DART SERVICE INSTRUCTION

TO AMEND INSTALLATION INSTRUCTIONS IIN-D412-769 REV. C AND
INSTRUCTIONS FOR CONTINUED AIRWORTHINESS ICA-D412-769 REV. 1

DRAWING NO. D412-769-1	TITLE AFT FACING SEAT ASSY, LH	REV. B	DART AEROSPACE LTD ENGINEERING ORDER	D.E.O. NO. D412-769-1-B-1	SHEET NO. SHEET 1 OF 2	SCALE NTS
DRAWN	CHECKED <i>UP</i>	MFG. APPR. <i>[Signature]</i>	APPROVED <i>[Signature]</i>	DE APPR. <i>[Signature]</i>		
DATE 12.07.09	DATE 12/7/10	DATE 12-07-10	DATE 12-07-10	DATE 12-07-10

DRAWING NO. D412-769-2	TITLE AFT FACING SEAT ASSY, RH	REV. B	DART AEROSPACE LTD ENGINEERING ORDER	D.E.O. NO. D412-769-2-B-1	SHEET NO. SHEET 1 OF 2	SCALE NTS
DRAWN	CHECKED <i>UP</i>	MFG. APPR. <i>[Signature]</i>	APPROVED <i>[Signature]</i>	DE APPR. <i>[Signature]</i>		
DATE 12.07.09	DATE 12/7/10	DATE 12.07.10	DATE 12.07.10	DATE 12.07.10

Figure 1: Addition of D4679-1 Spacer
(D412-769-041 shown, D412-769-042 similar)

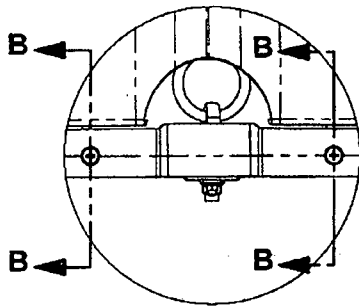
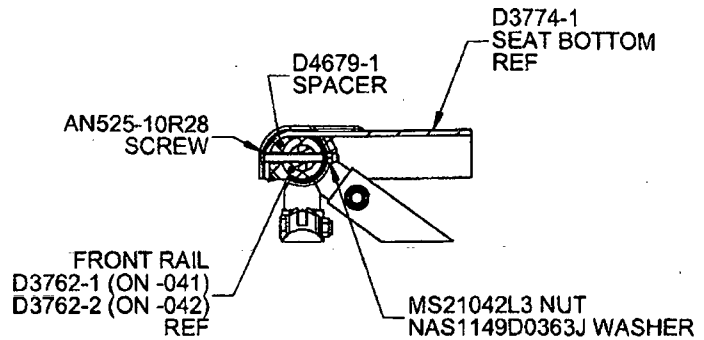
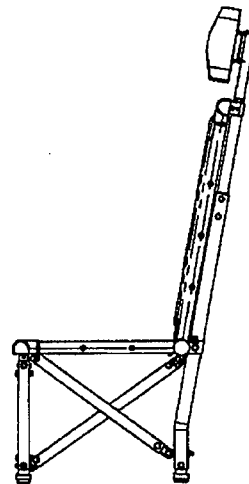
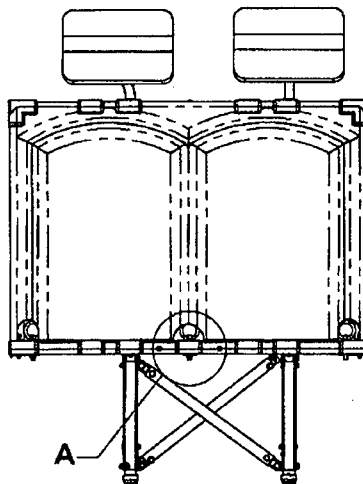
The purpose of this DSI (Dart Service Instruction) is to inform customers and operators that qty(2) D4679-1 Spacers were added to D412-769-011 Aft Facing Seat Kit and D412-769-041/-042 Aft Facing Seat, LH/RH at CHG 002 or later. This change also affects the hardware as shown in Figure 1 of this service instruction.

For replacement parts for D412-769-011/-041/-042 at CHG 002 or later, the parts list of ICA-D412-769 is updated as follows:

DETAIL L
SEAT BOTTOM ATTACH - FRONT DETAIL
2 PL

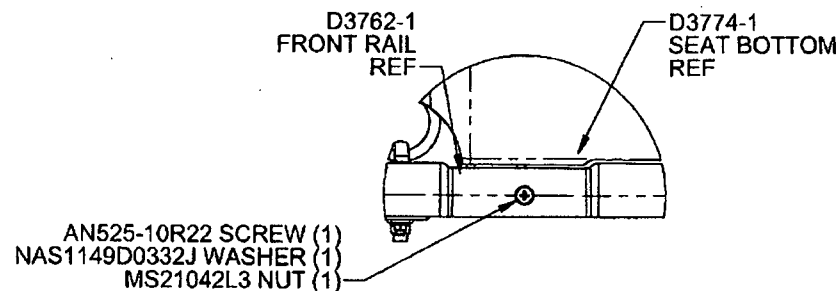
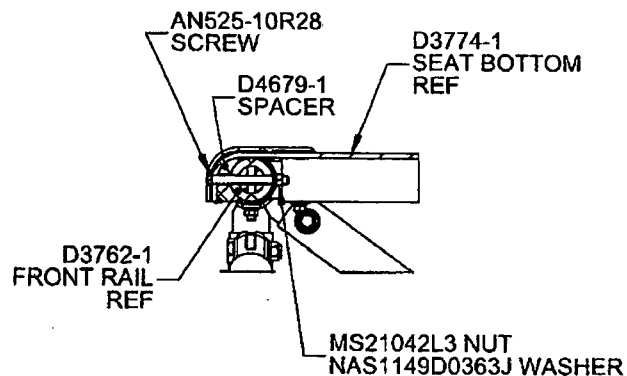
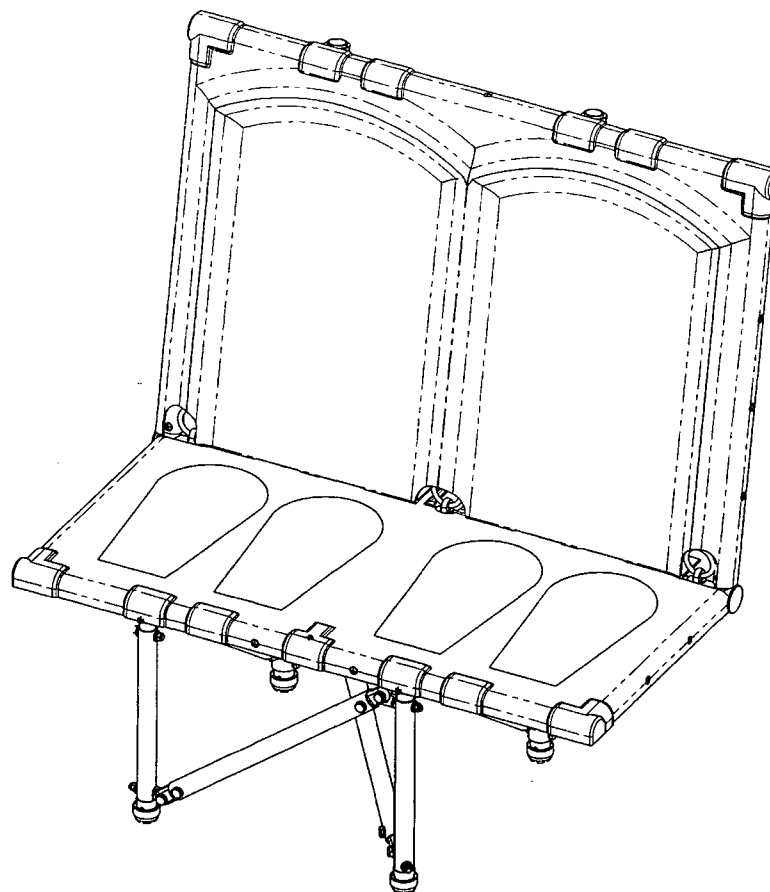
ADDITION OF QTY(2) D4679-1 SPACER PER PAR12-207.

IS:

WAS:

SECTION P-P
INSTALLATION OF D4679-1 SPACER
2 PL

DETAIL L
SEAT BOTTOM ATTACH - FRONT DETAIL
2 PL

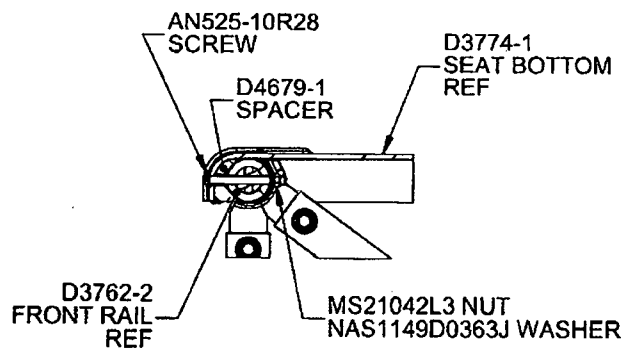
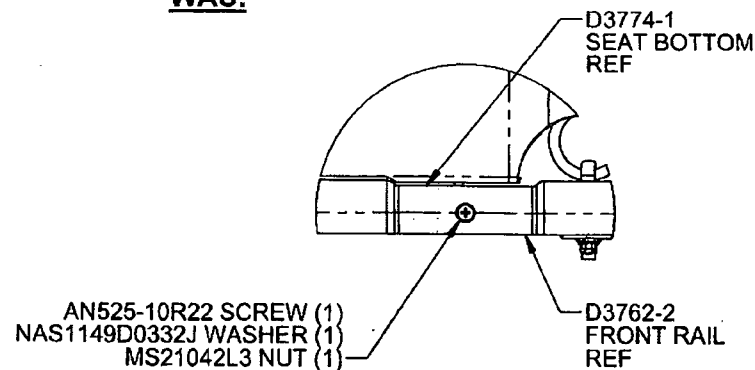
ADDITION OF QTY(2) D4679-1 SPACER PER PAR12-207.

IS:

SECTION P-P
INSTALLATION OF D4679-1 SPACER
2 PL

WAS:
